Intermodal Logistics Centre at Enfield

MODIFICATION APPLICATION

ILC –E – PT3A – Modification Application No. 4
REV A

31 August 2009

Figure 1 Approved Site Layout - SEDP 017F

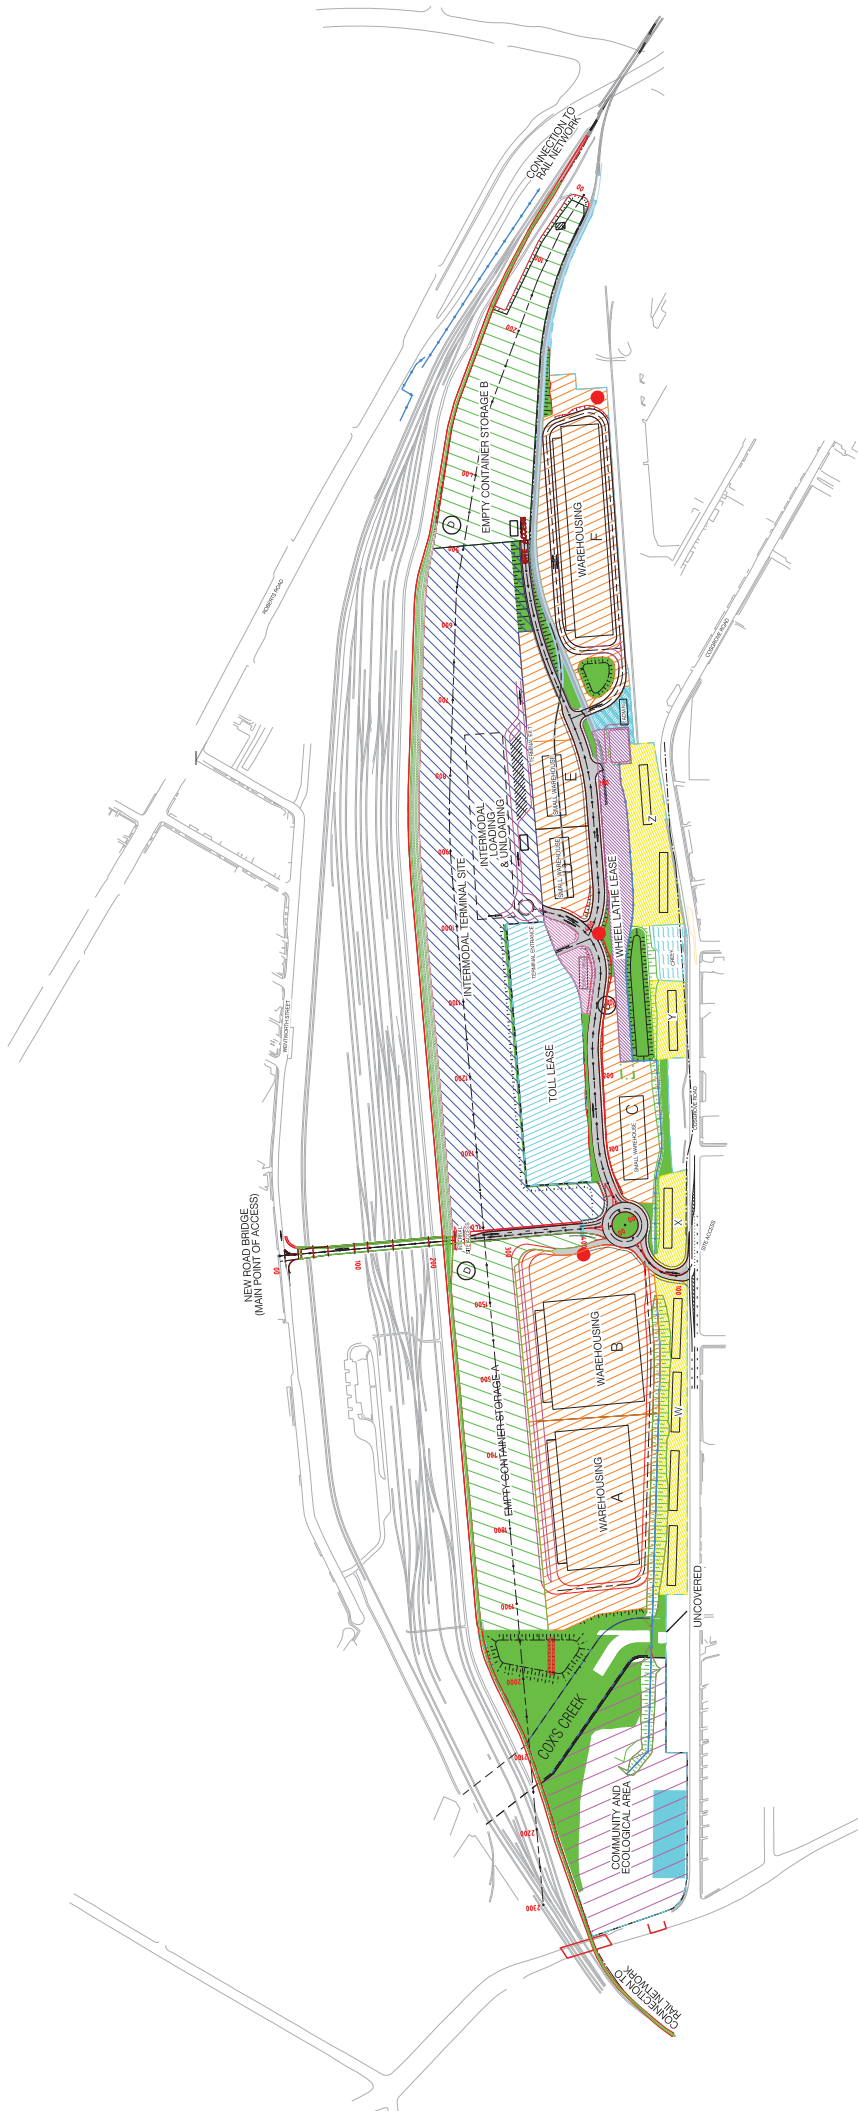
The location of the approved noise barriers/walls is shown on Figure 1 (originally Drawing SEDP017F, contained in SKM Project Notes dated 14 July 2007 and 6 August 2007 which are referred to in Condition of Approval 1.1.). The description of the approved noise barriers/walls provided in the approval documentation is summarised below.

The approved internal road layout for the ILC Site is shown on Figure 1 (originally Drawing SEDP017F, contained in SKM Project Notes dated 14 July 2007 and 6 August 2007).

The approved development incorporated three detention basins as shown on Figure 1 (originally Drawing SEDP017F, contained in SKM Project Notes dated 14 July 2007 and 6 August 2007). The basins were designed to ensure that peak discharges from the Site did not increase as a result of the development for each recurrence interval assessed (2, 10 and 100 years ARI). The site catchment areas and basins volumes from the EA are summarised in Table 4.1. The catchments modelled in the EA (SKM, 2005) are shown in Figure 13 of Appendix D of the EA.

FIGURE 2 SITE LAYOUT

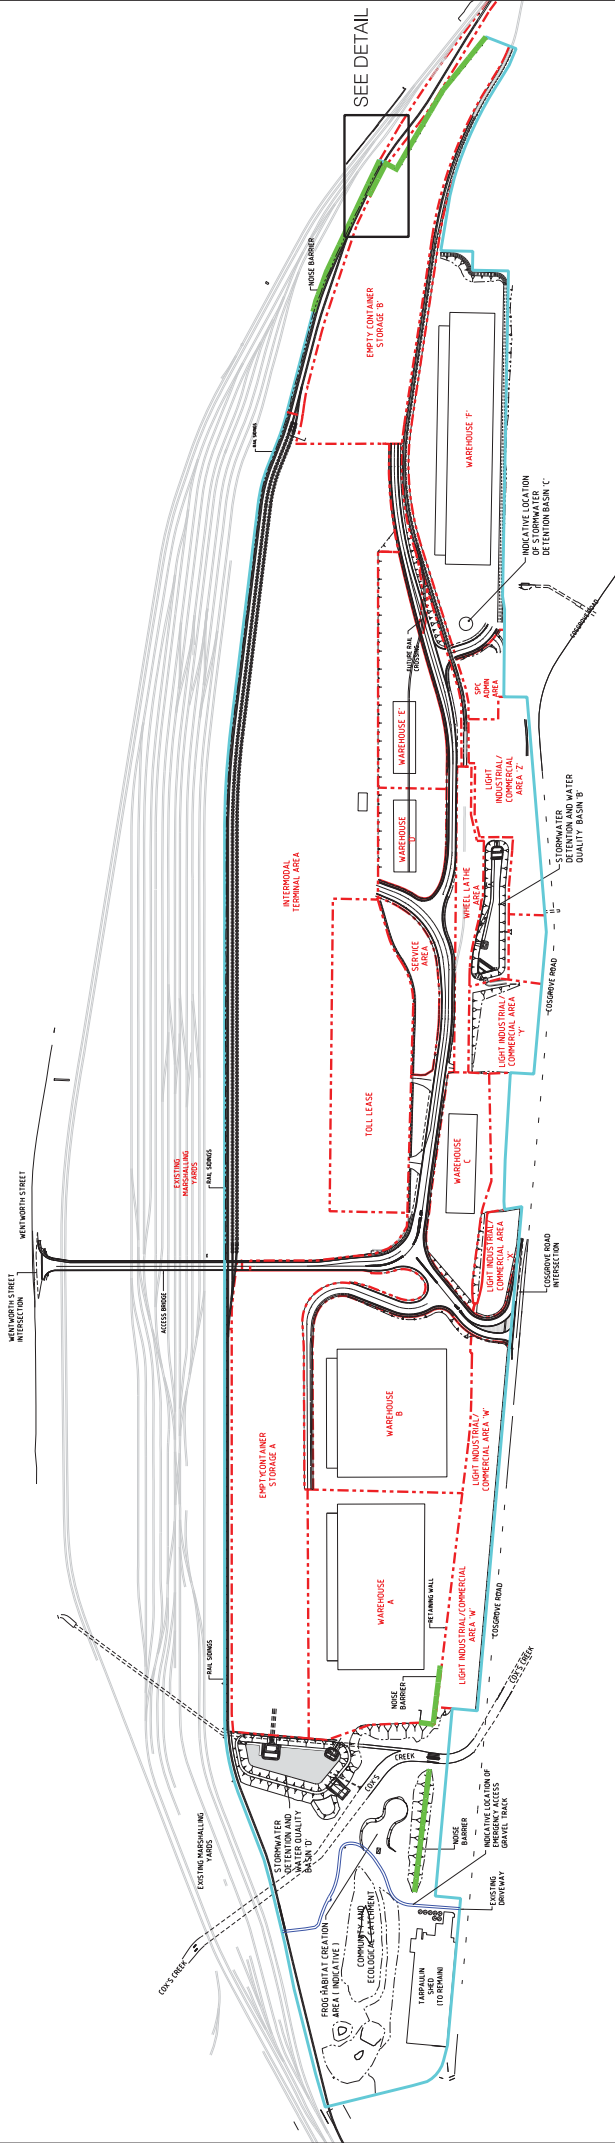
Sydney Ports proposes to relocate the northern noise wall east of the approved location to a location on the boundary of the ILC Site and RailCorp's New Marshalling Yards, as shown in Figure 2.

A noise wall 1.8 m high on top of an earth mound approximately 2.5 m high (total noise barrier heights of 4.3 m) is proposed in the south-east of the ILC Site, as shown in Figure 2. The proposed noise barrier would extend from the southern part of Coxs Creek towards the Tarpaulin Shed.

The noise barriers in the east of the Site, north of Coxs Creek, have been modified to include the following (refer also to Figure 2):

Consequently, noise barriers along the eastern part of the site (see above and Figure 2) have been modified to protect the residential area located to the south-east of the ILC site, with no noise walls proposed along the eastern part of the site to the north of Warehouse A.

The detailed design has resulted in improvements in the internal road layout as shown in Figure 2. In general, changes in the internal road are considered minor and generally consistent with the approved layout. The internal road improvements are listed below.

- Minor changes in the internal road layout routes as shown in Figure 2. For example, a section of the main intermodal access road has been moved marginally to the east so that it is located adjacent to the existing Wheel Lathe lease.
- Driveway access for the existing Toll lease area has been changed. The original access road to the north of the lease area has been deleted and two new driveway accesses have been added to connect to the existing southern-most driveways.
- Changes have been made to the widths of the internal roads and to the radii of the kerb returns to allow for B-Double turning movements throughout the Site. This will ensure that B-Double swept paths for left hand turns do not cross the oncoming traffic lane.
- A driveway for Sydney Ports' Administration Area has been added and the location of the driveway for the wheel lathe area has been relocated to the south.

Sydney Ports requests that Condition 1.1 of the Project Approval refer to the modified noise wall arrangement discussed in this document and shown in Figure 2.

Sydney Ports requests that Condition 1.1 of the Project Approval refer to the improved ILC Site layout, including the internal road layout, presented in this document and on Figure 2.

Figure 4-1 – L-shaped barrier at south-east of hard-stand area

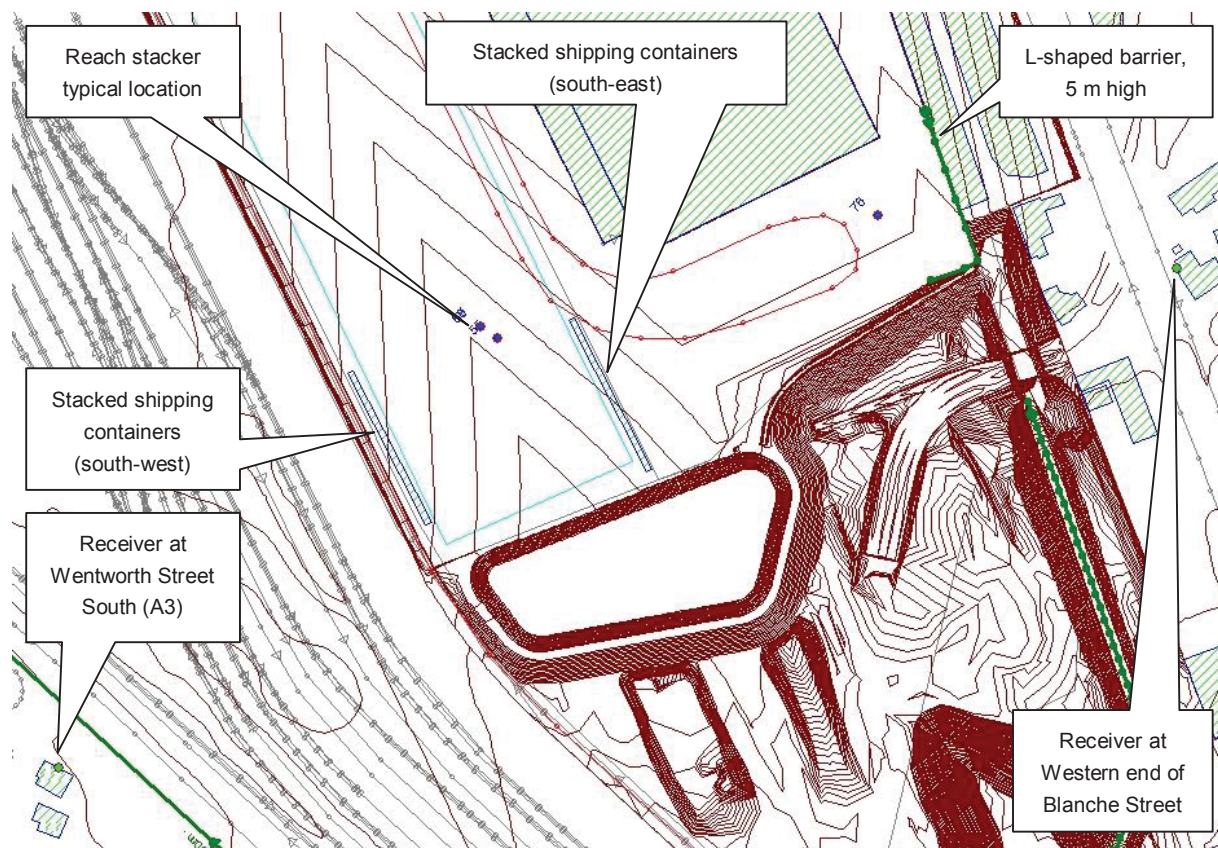
- 5 m high L-shaped noise barrier at the south-eastern extremity of the hard-stand area to the south-east of Warehouses A and B as shown in Figure 4-1;
- Stacked shipping containers (10 containers long by 4 containers high) at the south-eastern perimeter of the southern empty container area (between the empty container area and the hardstand adjacent to Warehouses A and B) as shown in Figure 4-1; and
- Stacked shipping containers (10 containers long by 4 containers high) at the south-western perimeter of the southern empty container area as shown in Figure 4-1.

- A barrier of 5.0 m in height and no less than 80 m in length at the south-eastern extremity of the hard-stand area to the south east of Warehouses A and B, refer Figure 4-1, *L-shaped barrier, 5 m high*. The barrier shall, from the south-eastern corner of the hard-stand area, run for no less than 60 m to the north and 20 m to the west. The barrier shall be contiguous and free from openings and/or gaps. Any material necessary to meet the Project Scope and Technical Requirements (PSTR) of having a 50 year design life is likely to provide the required transmission loss (TL); however, the anticipated material for a barrier of this height and length is a concrete tilt-up panel or similar. The intent and purpose of the barrier is to provide shielding to the receivers at the western end of Blanche Street from vehicle movements south of Warehouses A and B and supplement shielding from reach stacker operations provided by:

- Stacked 40-foot shipping containers at the south-eastern corner of the southern ECS area, stacked 10 long and four high, refer Figure 4-1, *Stacked shipping containers(south-east)*. The presence of the barriers is required whenever reach stacker operation is occurring in the southern ECS area. The intent and purpose of the containers is to block direct line of sight from reach stacker operations to the receivers at the western end of Blanche Street; (note the actual location would be dependent upon the area of any concentrated activity on any given night of operation); and

- Stacked 40-foot shipping containers at the south-western corner of the southern ECS area, stacked no less than 10 long and four high, refer Figure 4-1, *Stacked shipping containers (south-west)*. The presence of the barriers is required whenever reach stacker operation is occurring in the southern ECS area. The intent and purpose of the containers is to block direct line of sight from reach stacker operations to the receivers at the southern end of Wentworth Street (note the actual location would be dependent upon the area of any concentrated activity on any given night of operation).

Figure 4-2 – Barrier at south-east southern landscaped area

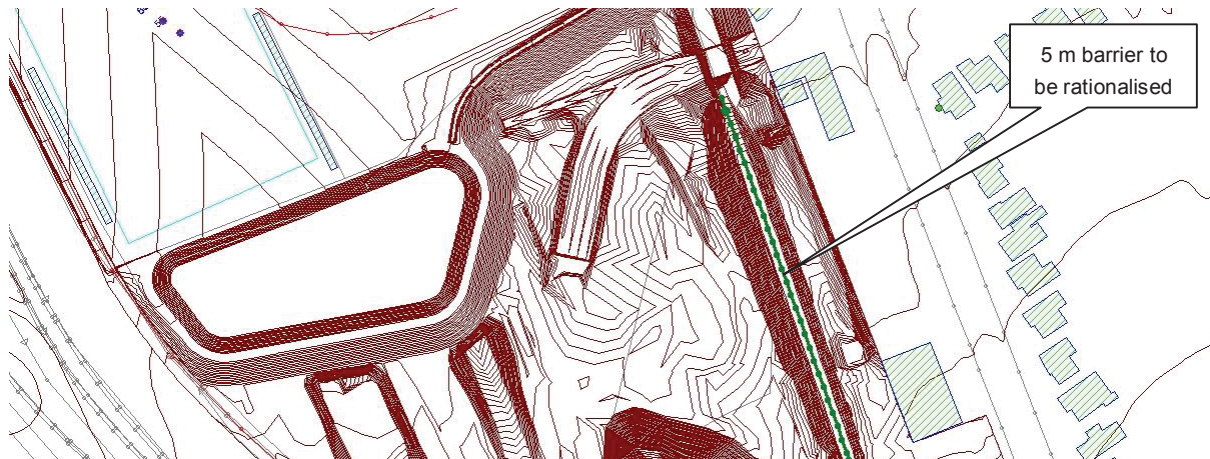
- The 5 m high barrier at the eastern perimeter of the landscaped area at the southern extremity of the Enfield ILC site appears, (on the basis of detailed design noise modelling) not to control any exceedances, i.e.: does not provide a required acoustic function. SPC has informed AECOM that the barrier will remain for non-acoustical reasons (such as security) and as such a barrier of 1.8 m on top of the 2.5 m mound at that location has been included in the model. Refer to Figure 4-2:

Figure 4-3 – Roberts Road barrier reconfiguration

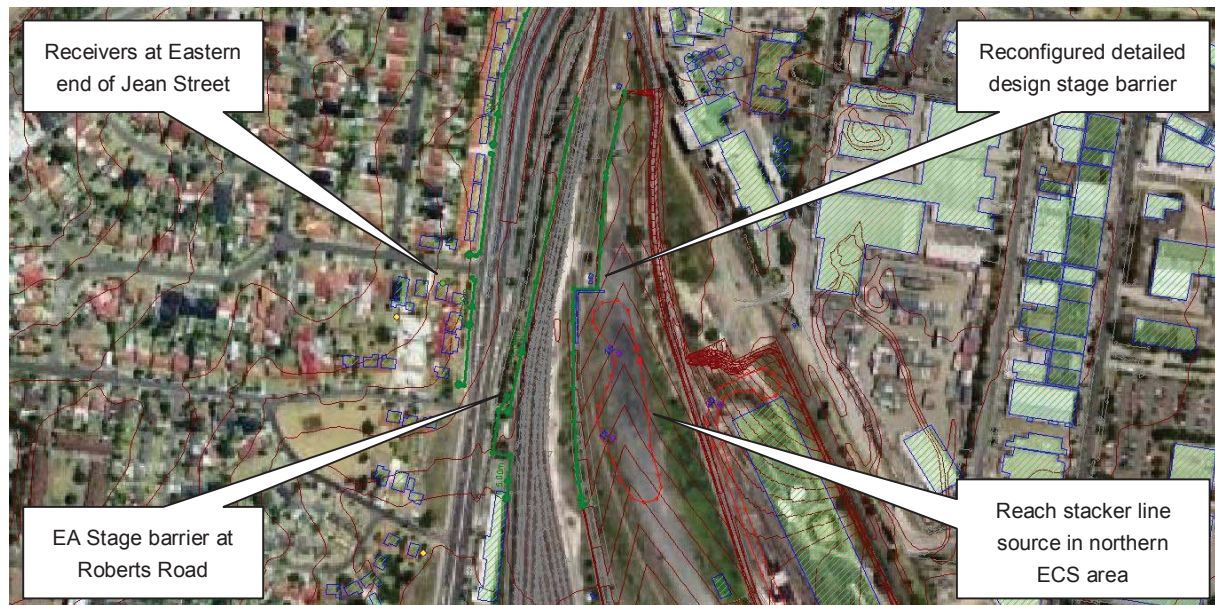
- AECOM understands that the 'Roberts Road barrier' proposed at the EA stage to control noise emission from the northern area to receivers on the western side of Roberts Road (and on the basis of detailed design stage modelling results in marginal exceedances under neutral meteorological conditions of up to 2 dB(A)) cannot be considered further, due to non-acoustical reasons. It is therefore necessary to investigate alternative barriers at the northern end of the site and the 'with mitigation model' incorporates a barrier of the same height (5 m) and length (approx 390 m) which has been positioned at the western-most boundary of the northern ECS area – refer to Figure 4-3:

- A barrier (in one or two sections) of 5.0 m in height and no less than 375 m in total length running along the western boundary of the northern ECS area (i.e.: west of the rail sidings), refer Figure 4-3, 'Reconfigured detailed design stage barrier'. The barrier shall, from the northern-most point of the northern ECS area run 157 m south (following the site boundary) form a return of 21 m to the west and then follow the western boundary of the site for 178 m to the south. Alternatively, it is permissible to provide two overlapping barriers with an opening between (to enable rail access from the ILC to the rail corridor) on the condition that the overlap distance is equal to or greater than four (4) times the distance between the two barriers. The northern-most section would extend for approximately 197m and overlap the 178 m long southern section by approximately 40 m. The barrier(s) shall be contiguous and free from openings and/or gaps. Any material necessary to meet the Project Scope and Technical Requirements (PSTR) of having a 50 year design life is likely to provide the required transmission loss (TL); however, the anticipated material for a barrier of this height and length is a concrete tilt-up panel or similar; and
